Clinch River Nuclear Site  
NRC Docket No. 52-047

Subject: Submittal of Supplemental Information Associated with Hydrologic Engineering in Support of the Clinch River Nuclear Site Early Site Permit Application

Supplemental Information Regarding Site Safety Analysis Report Section 2.4,  
“Hydrologic Engineering”

Figure 2.4.3-17. Unit Hydrographs, Sub-basins 1-6 (Sheet 1 of 8)

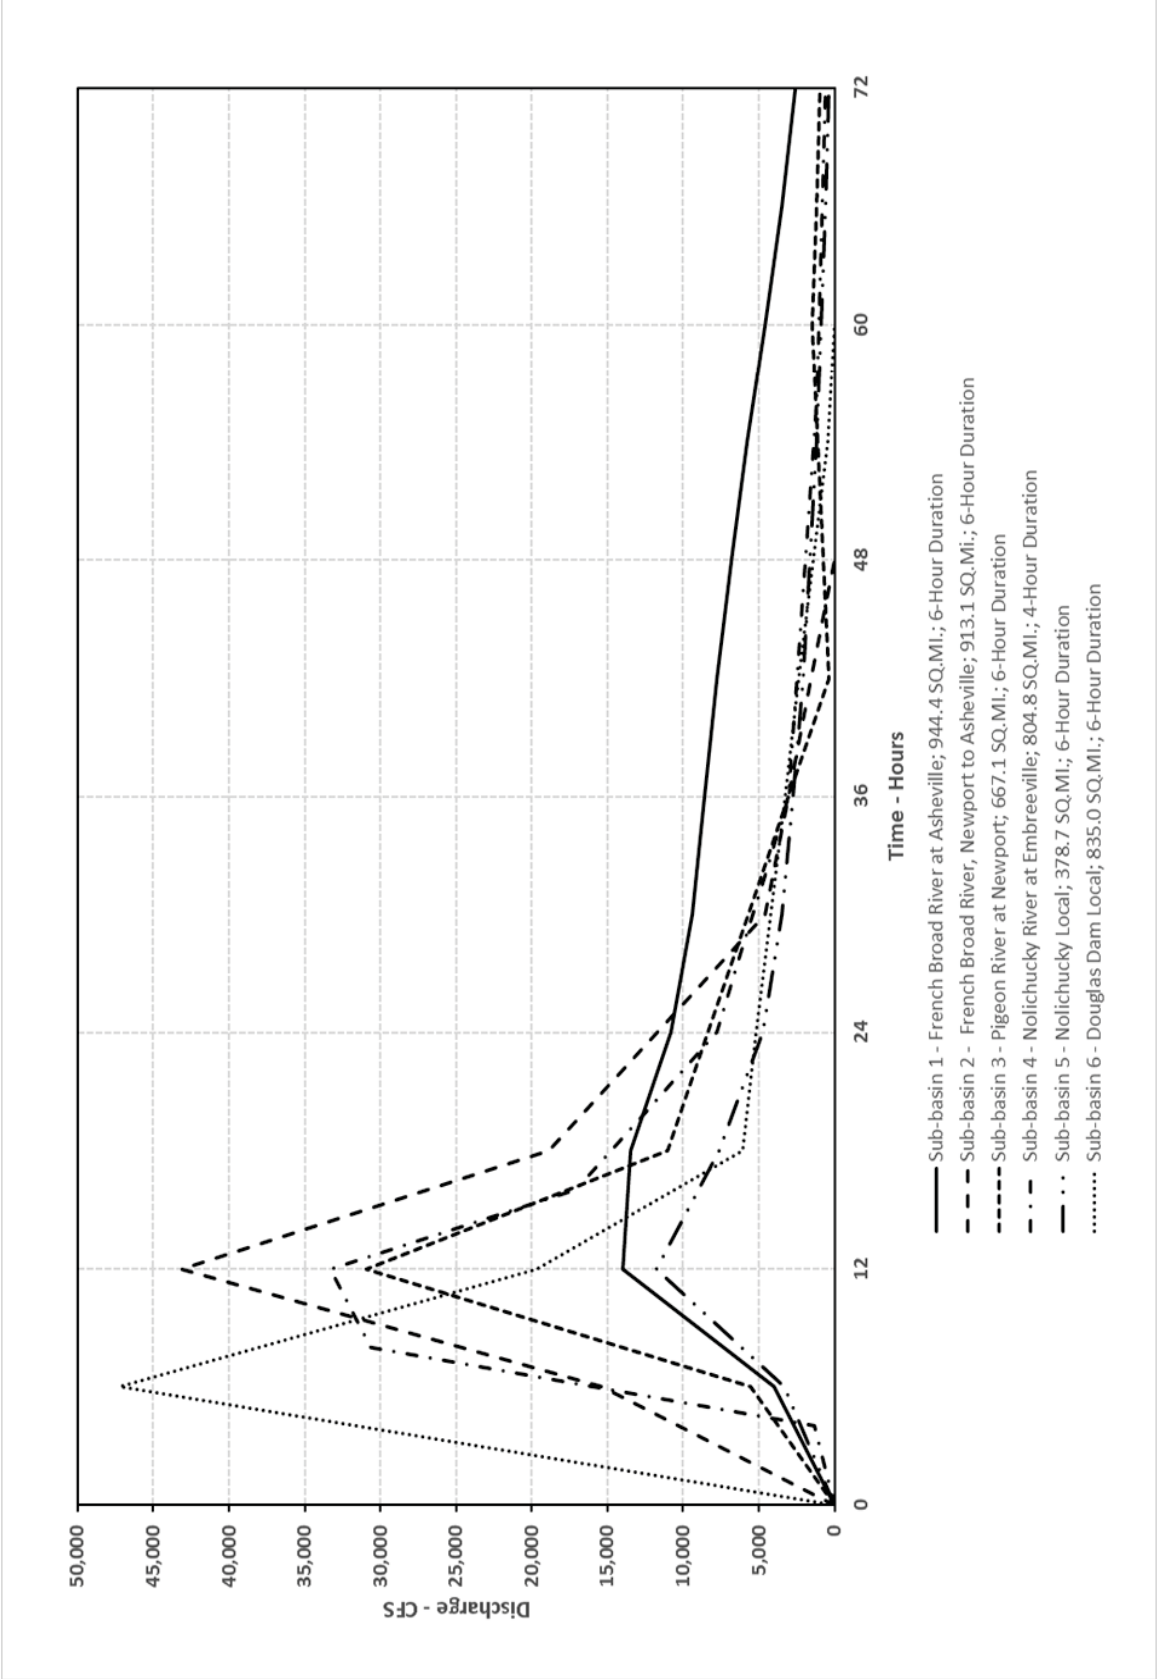
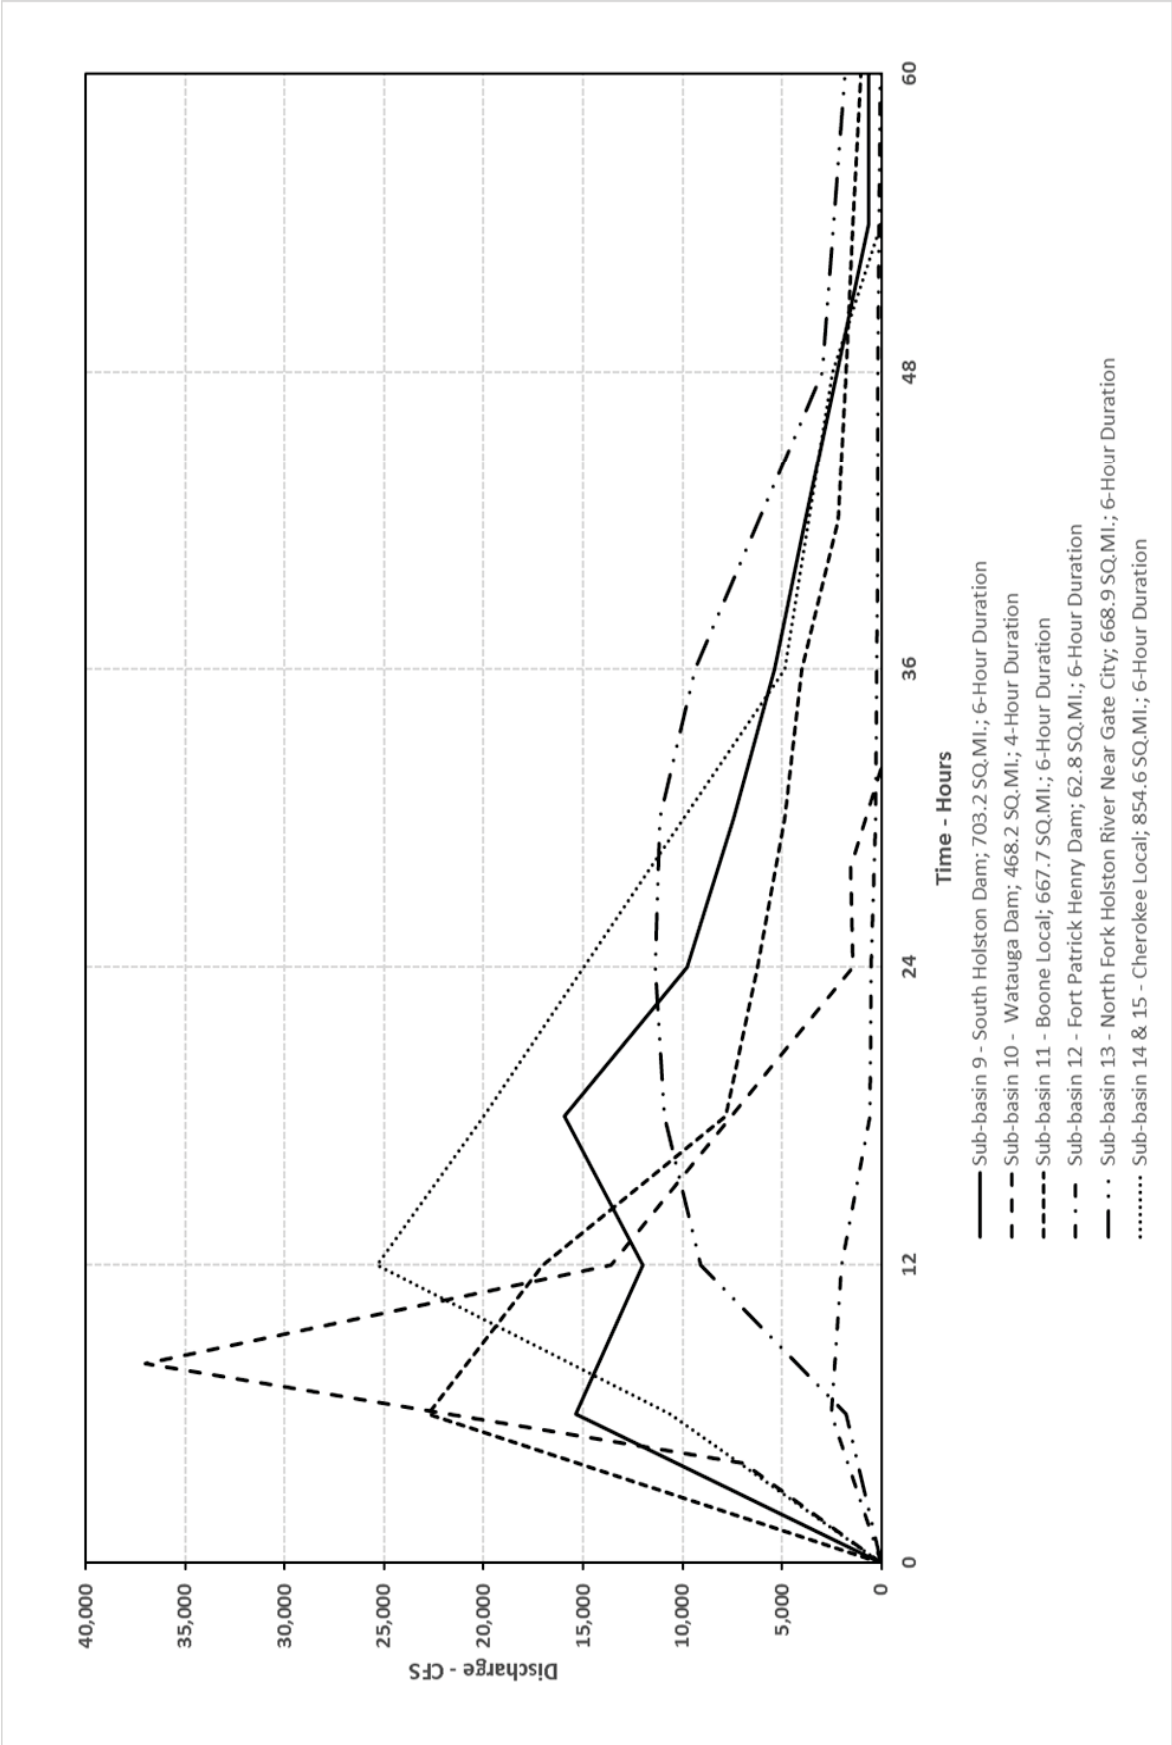
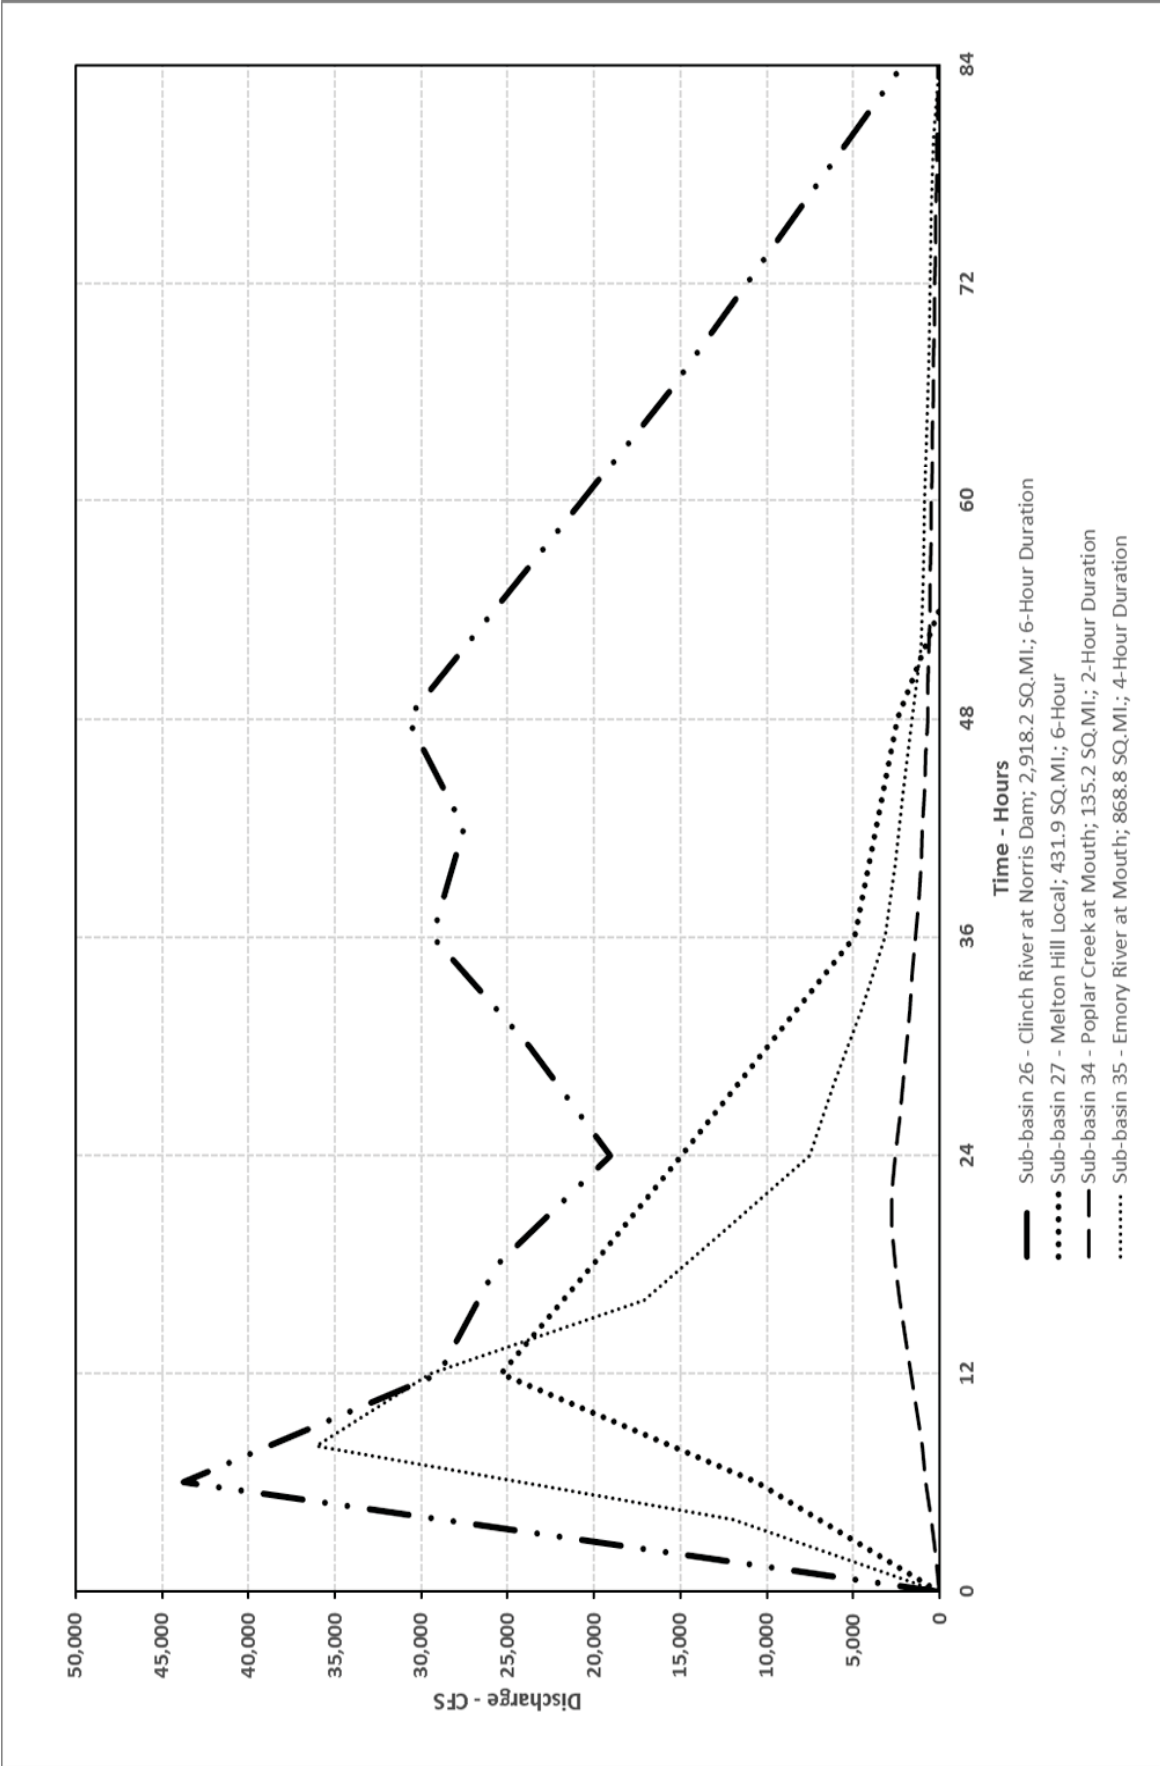
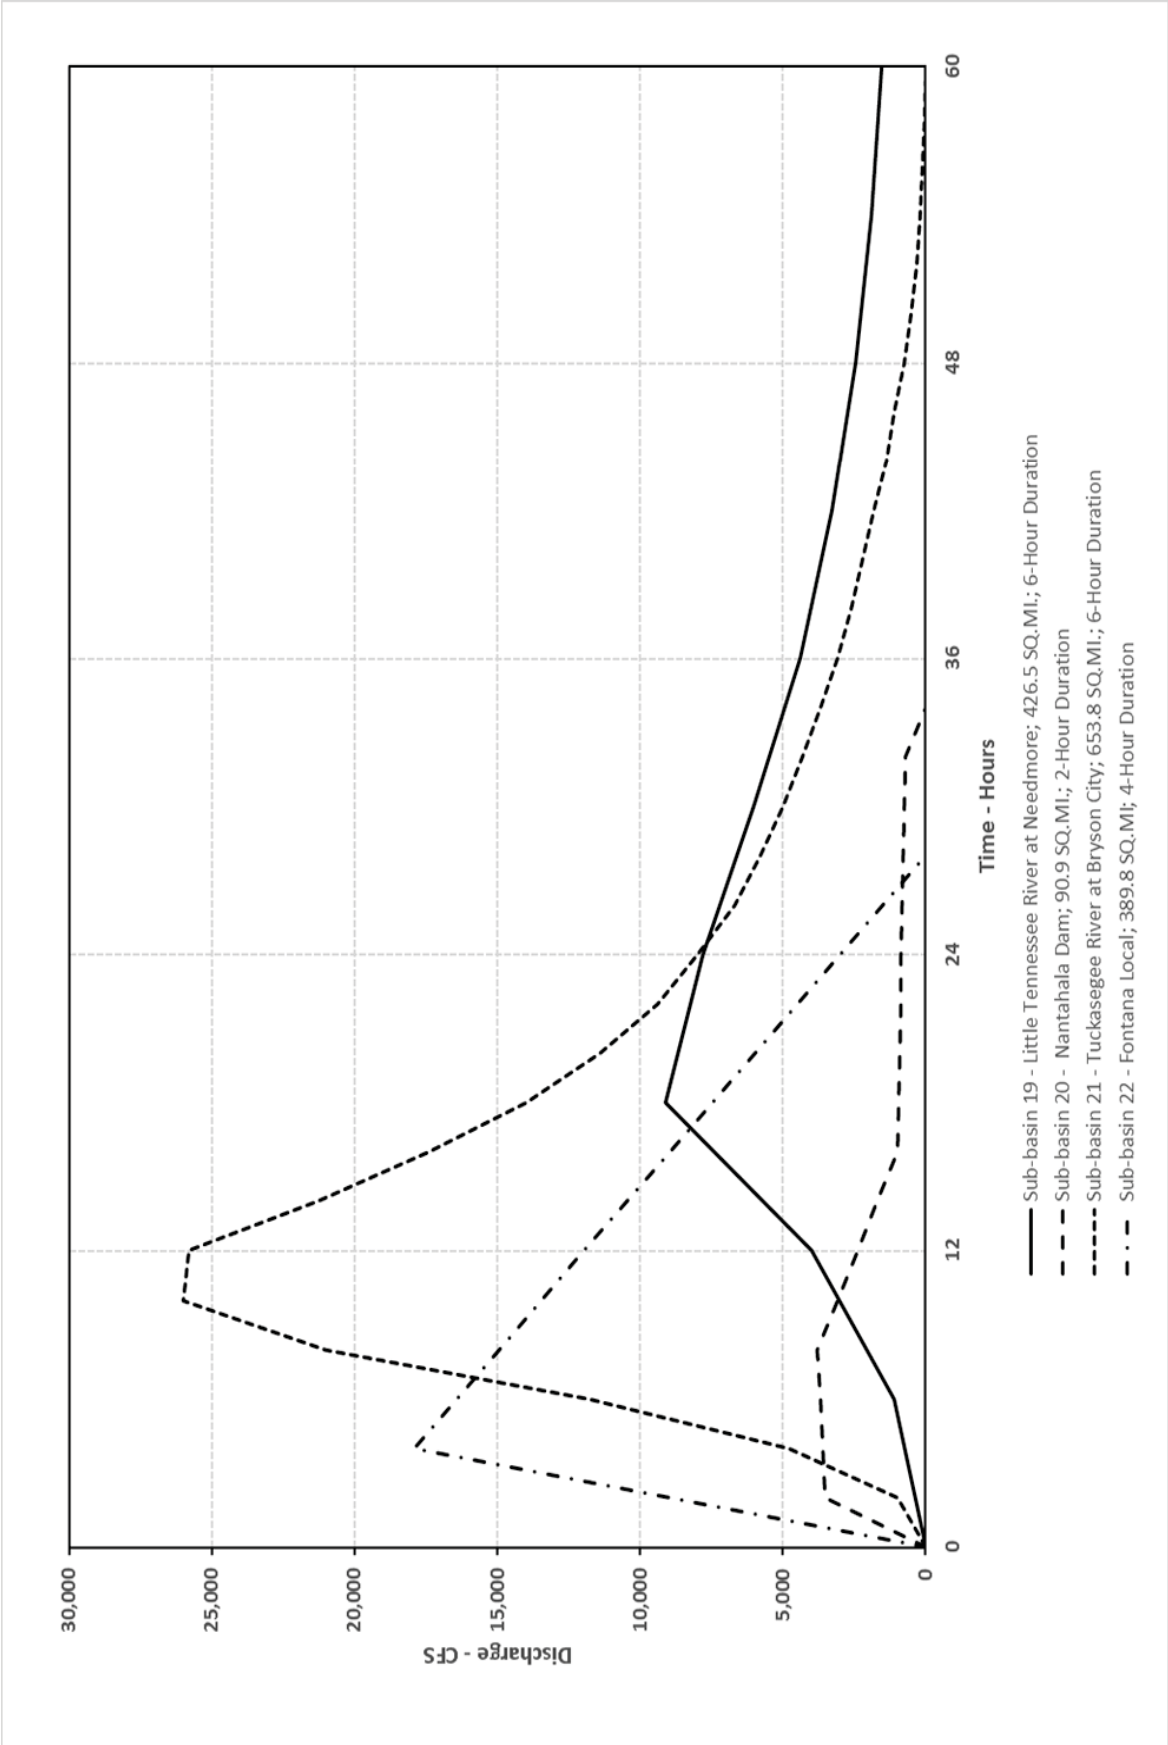
A discussion of how the Unit Hydrographs (UHs) were developed, including validation of the UH's is being added, under a subheading titled "Unit Hydrograph Development and Validation," to SSAR Subsection 2.4.3.4.1, "Runoff Model." Validated unit hydrograph figures and reference to those figures are also being added with this revision. In addition, a discussion of how the inflows were determined for the 1973/2003 storms used in the calibration is being added to SSAR Subsection 2.4.3.4.3, "Stream Course Model Geometry Development and Calibration." For these changes, see the markup provided in SSAR Subsection 2.4.3.4.1, subheading "Unit Hydrograph Development and Validation," addition of new Figures 2.4.3-17, Sheets 1 through 8, and Figures 2.4.3-18, 2.4.3-19, and 2.4.3-20, and SSAR Subsection 2.4.3.4.3, the eighth paragraph, in Attachment 3.
